## Section 2.0 - Specification for Abatement and Selective Demolition Amendment

## **Amendment #7 REV01**

Premise Address: <u>130 Cedar Street</u>

Re: VAR# <u>2887MN07</u> TRU#: <u>2011MN07</u>

ELEV. MACH. ROOM

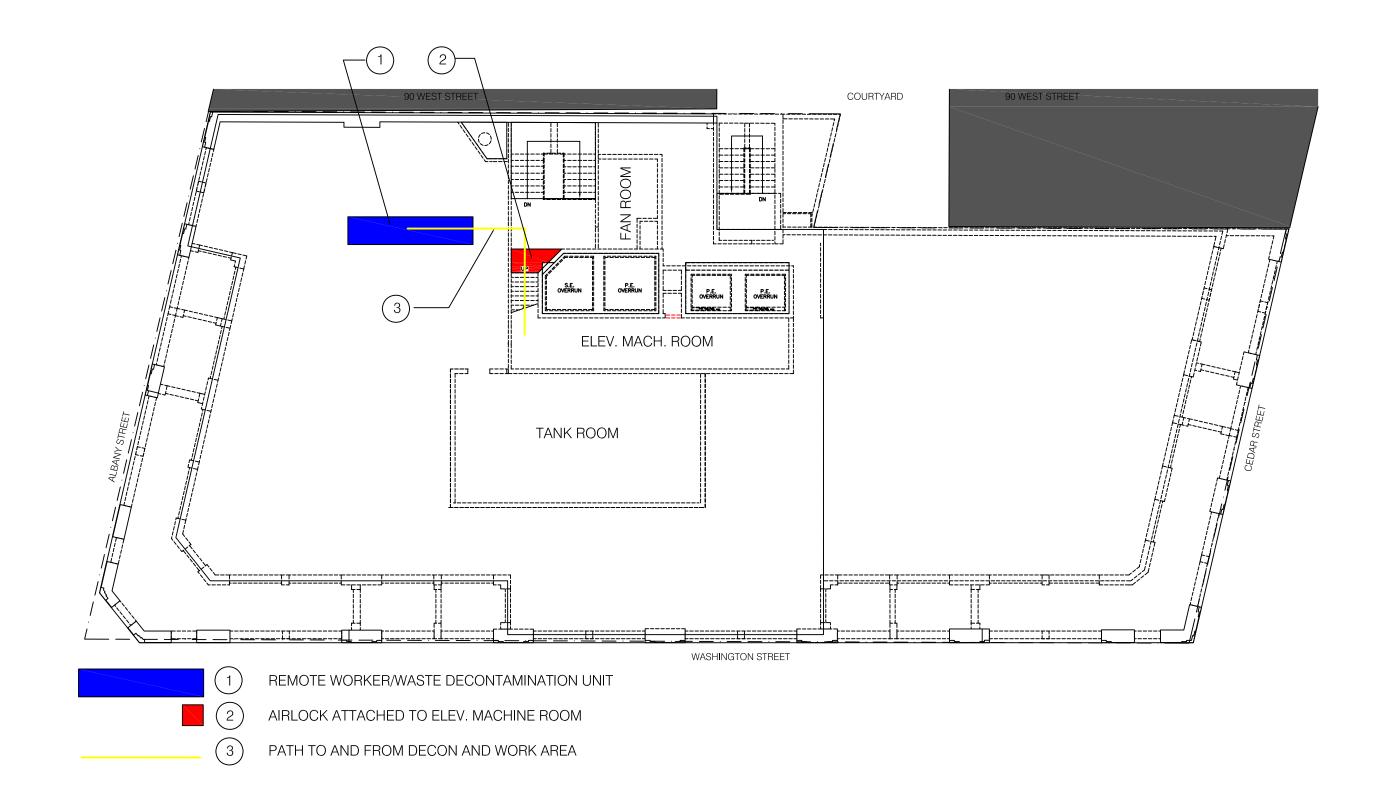
In our previous proposal it was stated that final cleaning and clearance of the Elevator Machine Room would be performed in Phase III-J, Work Area 16 concurrent with the Elevator Shaft. Due to the fact that there are asbestos containing materials located in the elevator machine room necessary for the normal operation of the elevator and that fact that the elevator was utilized to perform abatement, final cleaning and visual inspection by the regulators it was necessary to exclude the Elevator Machine Room from this work area until the elevator is shut down.

Furthermore, FDNY requires that the roof is accessible from Stairwell C. Constructing attached decontamination units either inside the stairwell or tunnels leading to the decontamination units located on the roof is prohibited. A one stage airlock previously constructed per FDNY requirements currently attached to the elevator machine room will be used to access this area.

Workers will access the elevator machine room from the decontamination units located on the roof through the door leading to the top of stairwell C. Once inside the stairwell workers will enter the attached airlock on the 12<sup>th</sup> floor level leading to the elevator machine room. (see attached drawings)

Prior to entering the elevator machine room workers will put on two Tyvek suits and required personal protection inside the worker decontamination enclosure system clean room and proceed directly to the work area as stated above.

Prior to leaving the work area or at the end of each shift, all personnel shall HEPA vacuum their outer suits and respirators inside the work area, proceed to the airlock, remove their outer suits in the airlock and put on one clean suit and proceed directly to the remote decontamination unit on the roof.
Sincerely,
Christopher Flavell Nova Development Group, Inc.
